SECTION 1 DESCRIPTION OF THE PROJECT				
No.	Review Question	Relevant?	Adequately	What further information is needed?
1.16	Is the reinstatement and after use of land occupied temporarily for operation of the Project described? (e.g. land used for mining or quarrying)	Yes	Yes

The main rEIAS document, namely Chapter 10 – Soils, Geology and Land, Document No.: QS-000280-01-R460-001-000, submitted by ESB is essentially a synthesis of data and procedures rather than a presentation of the core factual information. The details of actual procedures, key data and decision-steps are largely contained in an Appendix titled Chapter 10 – Soils, Geology and Land Appendices, Document No.: QS-000280-01-R460-001-000.

**Figure 1:** Contents of Appendices as listed in the Chapter 10 Main Chapter

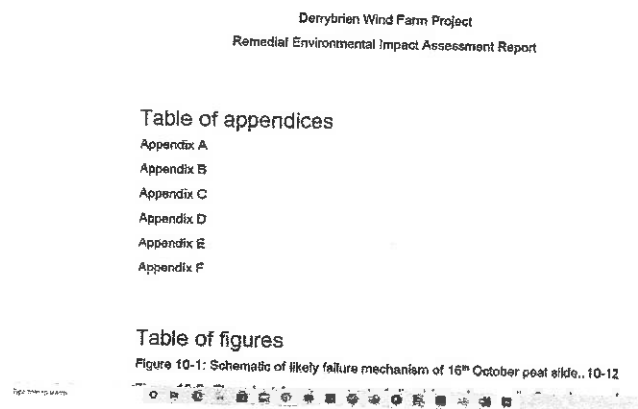
The rEIAS document provides a list of contents for the document itself, but provides no information in the Contents pages about what is contained within the Appendices (see attached Figure).

This provided list of Appendices suggests that there are six Appendices, A – F, but what these contain and what their significance might be is left to the reader to guess. Turning to the Appendix document itself (namely Chapter 10 – Soils, Geology and Land Appendices, Document No.: QS-000280-01-R460-001-000), this provides no Contents page or Index at all, other than the contents pages of the individual reports presented within the appendices – to which there is no guide at the start of the document. Furthermore, it emerges that there are not six Appendices but instead a nested multitude of Appendices, in some cases going down as far as four levels of Appendix.

Lacking any sort of Contents page, this 2640-page document would be considered by many to be not fit for purpose, particularly as much crucial information is provided only within the Appendices document rather than in the rEIAS itself. As such, this raises questions about whether the rEIAS is itself fit for purpose.

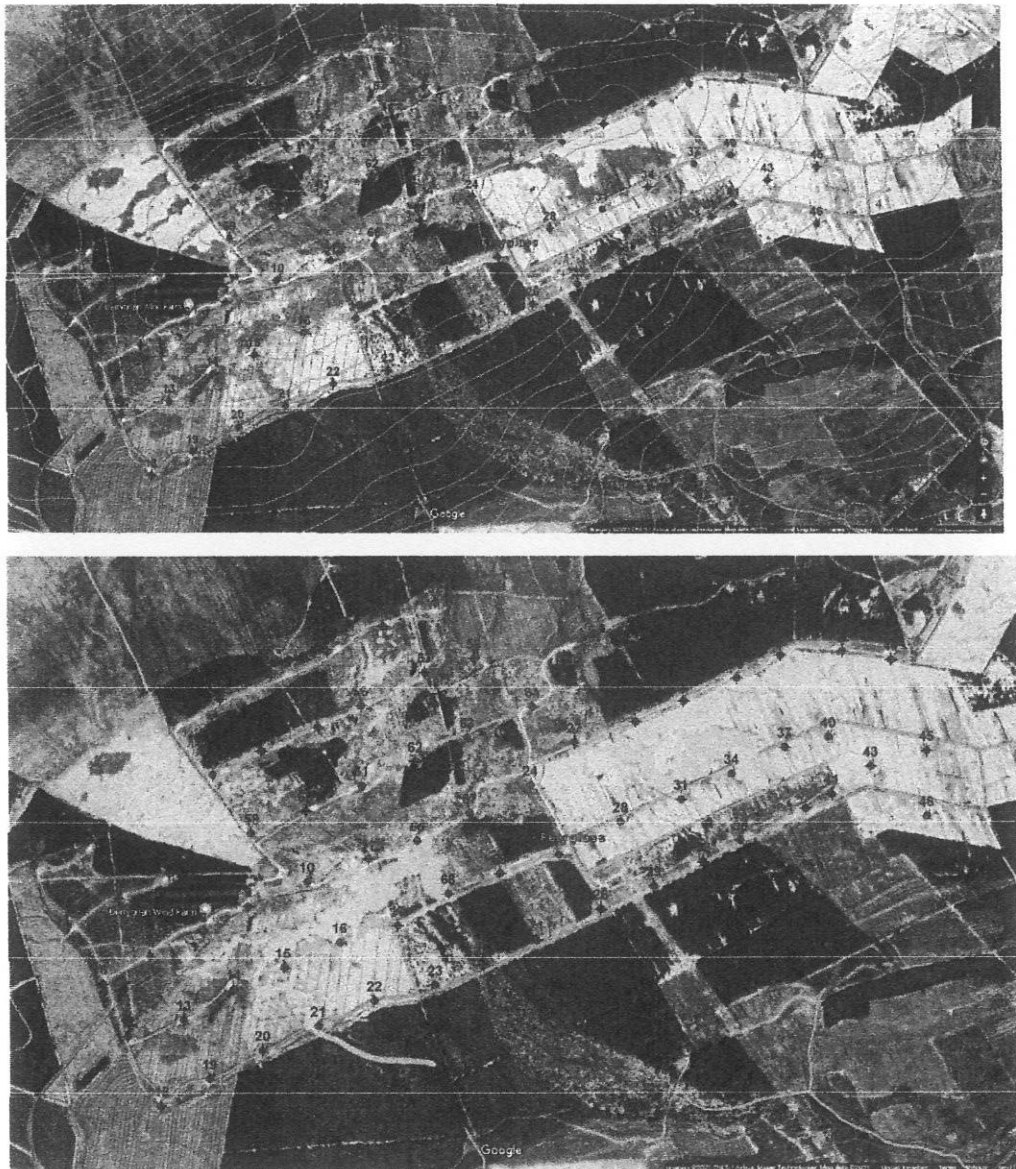
It seems likely that there is further failure in basic mapping of the ground condition in terms of how the information obtainable from aerial photography has been interpreted. With reference to the aerial photographs provided as ‘Figure 10-4 in Section 10.2.1.3’ of the rEIAS and ‘Figure 2-1 of Appendix E’, the latter figure points to a dark sinuous band of colour crossing the turbary area and describes it as ‘*deep peat along subsurface drainage channel*’ which is undoubtedly the case, given the sinuous nature of the dark shading.

A similar band of sinuous shading which forms a huge crescentic shape leading down into the same ‘shallow valley’ which experienced the 2003 peatslide (see Figure 2) is merely identified (along with others) as an ‘*Area of deeper peat and high water table on flat terraces (Darker vegetation)*’ but with no mention of the (very likely) possibility that this, too, is an area of sub-surface piping and/or seepage. Furthermore, the dark zones identified in the NW corner of the aerial photograph and lying just outside the windfarm boundary actually point downslope and converge on a natural drainage line, so it is possible that these, too, are seepage zones or areas of sub-surface piping.

Further areas of dark ground can just be discerned vanishing into the forest blocks within the windfarm site, so it is possible that sub-surface seepage is widespread within the site. These may be natural zones of seepage, but published evidence from, for example, Holden *et al.* (2002) and Holden (2005) have identified a clear linkage between drying peatlands and prevalence of sub-surface piping.

It should also be noted that the heads of the pale blue seepage zones in Figure 2 all begin along the line from Turbines 27 to Turbine 42.

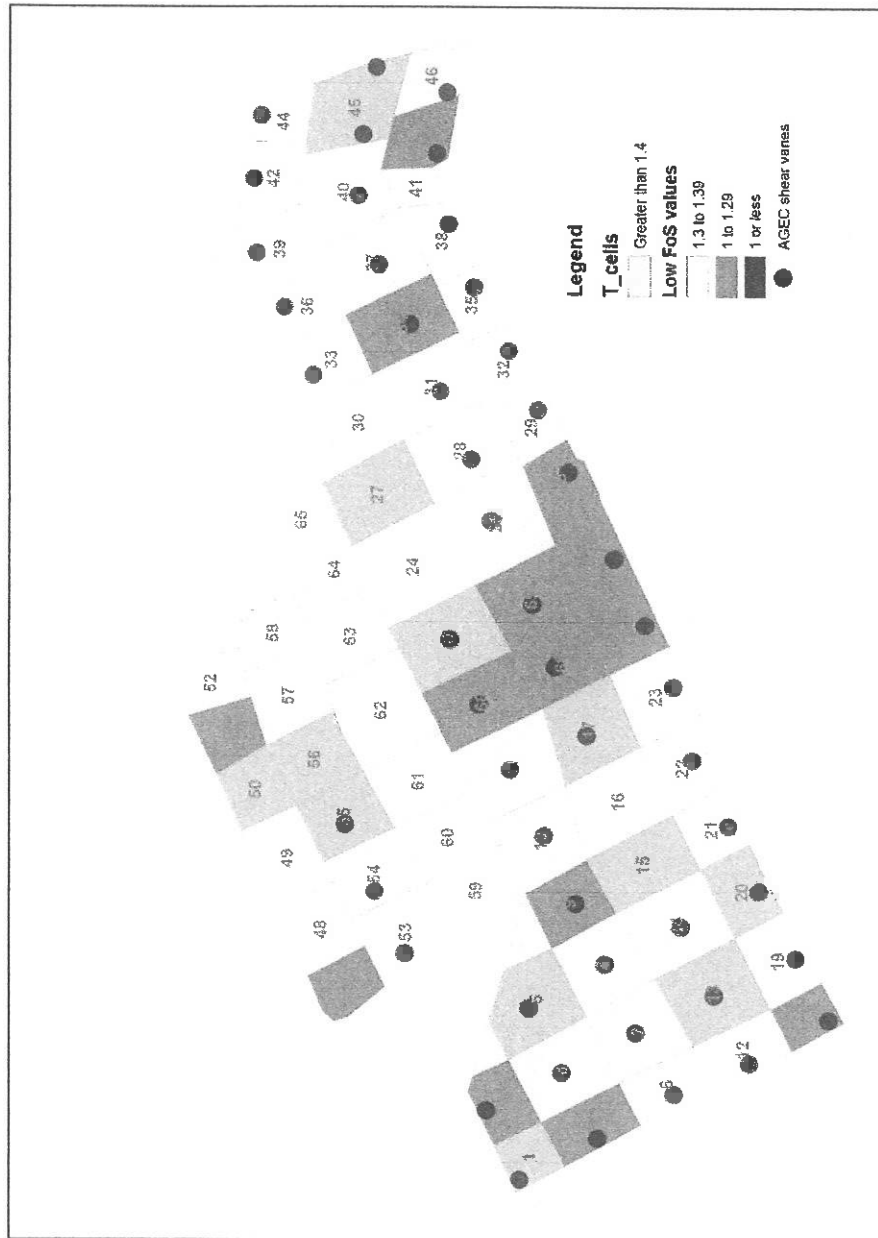
Secondly, the FoS calculation for each T-cell was based on testing the peat in only a single location in each T-cell, and even this in only a proportion of the full set of T-cells (see Figure 6).

**Figure 8.** Peat Stability Assessment by AGL (2020) for baseline conditions in 1998 for each T-cell. Highest risk rating is '5'. Note the concentration of high risk cells in the northern section of the site, and also the high risk value along the western margin of the site.

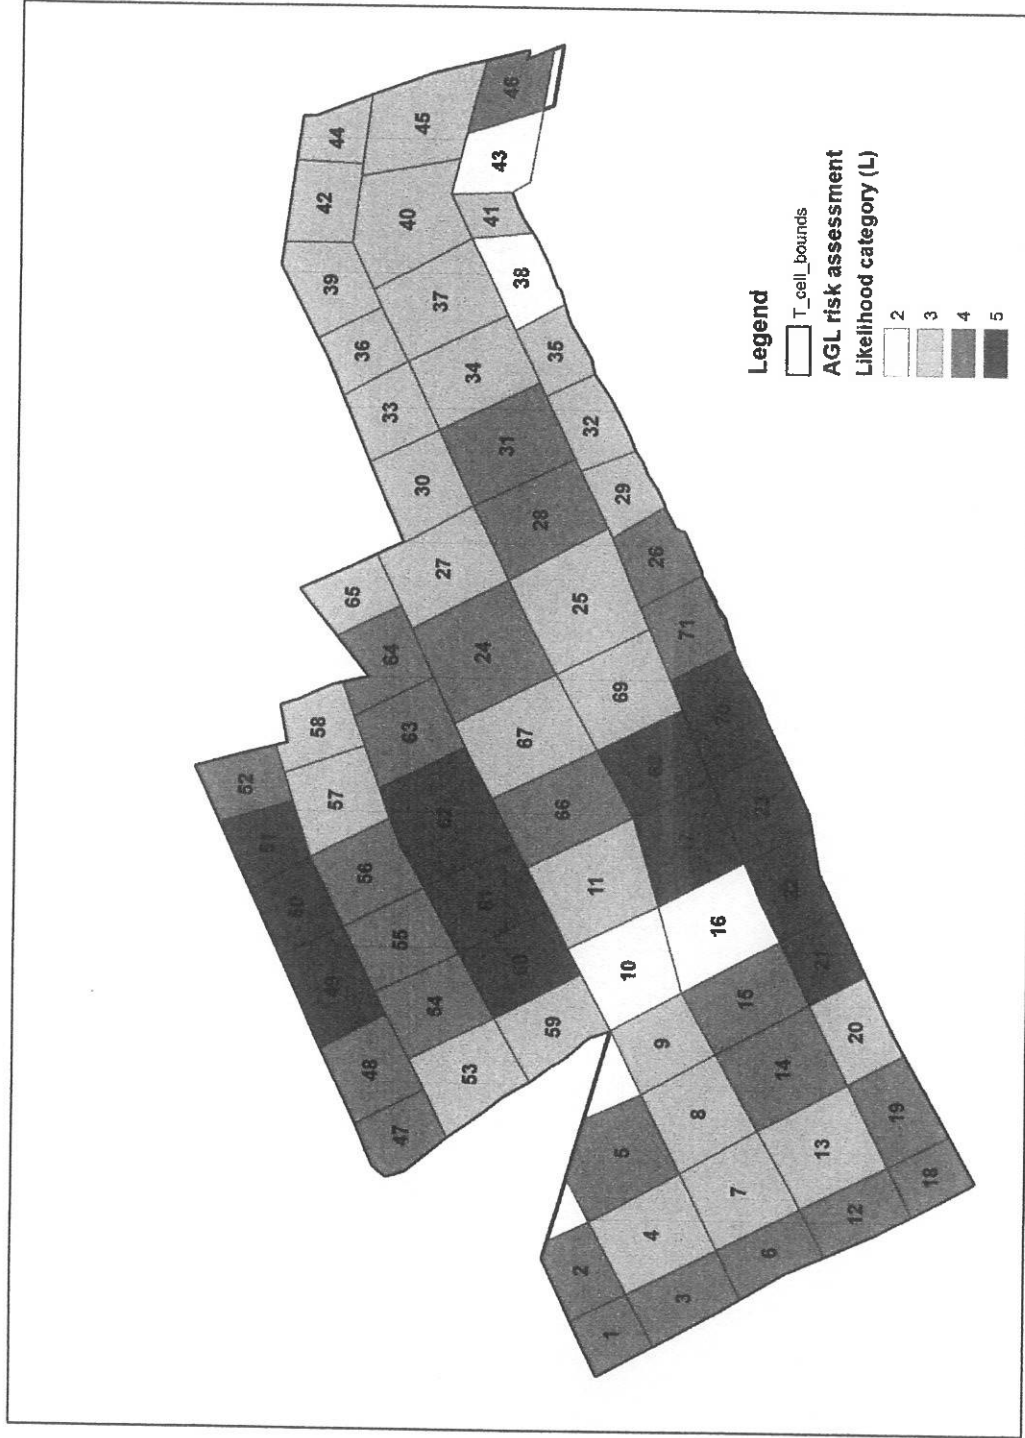
significant risk of instability and consequent impact (see Figure 8). The distribution of shear vane tests in relation to this assessment can be seen in Figure 9, while correspondence with the original 'worst-case' map generated by AGECE (2004) can be seen in Figure 10.

What is most striking about the areas identified as being at risk in by AGECE (2020) is the clear concentration of T-cells at risk in the northern sector of the site, mirroring the already-failed area of the 2003 slide to the south. This region remained largely un-surveyed by AGECE (2004) so the main records for peat condition come from ESBI (2005). Even after this survey, however, some critical T-cells remain largely un-tested, as can be seen from Figure 9. They still emerge as being significantly at risk because of other risk factors. Concentration of high-risk areas in the northern and western parts of the site is reinforced by the findings of the AGECE (2004) report, as can be seen in Figure 10.

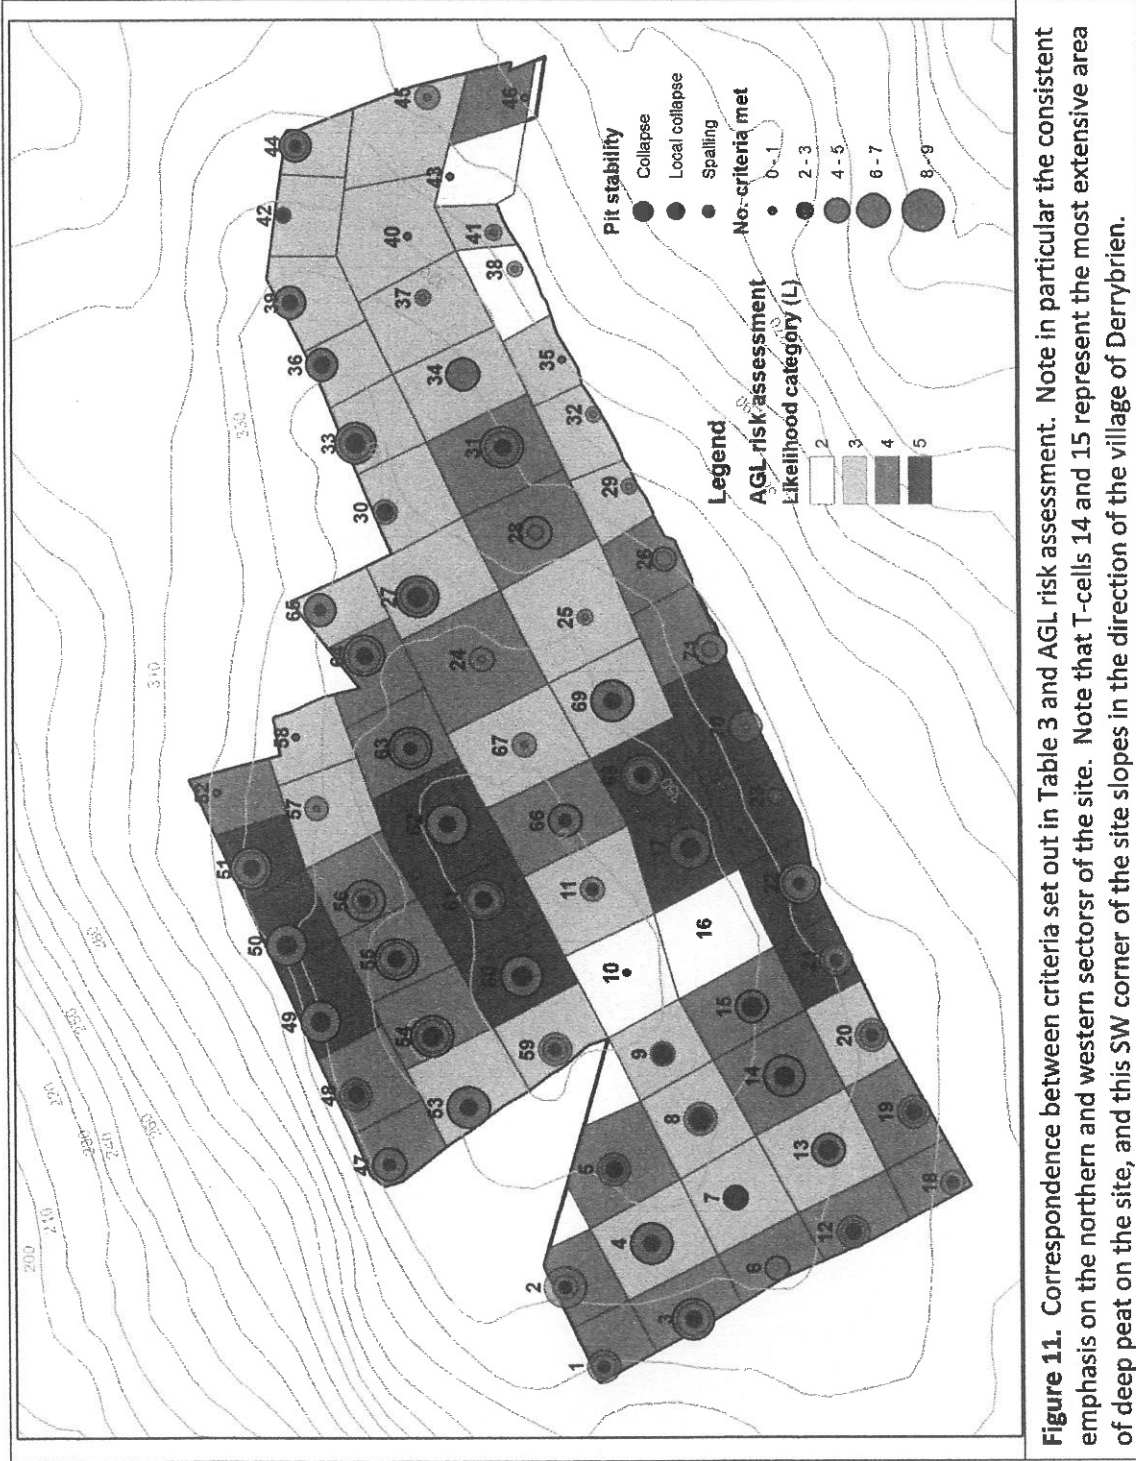
Figure 11 compares the distribution of T-cells at risk based on the data in Table 3 with the distribution of at-risk T-cells presented by the rEIAS (and shown in Figure 8 above). From this it can be seen that there is good correspondence across all those T-cells identified in the rEIAS, but the revised assessment based on the data in Table 3 highlights a number of additional T-cells.
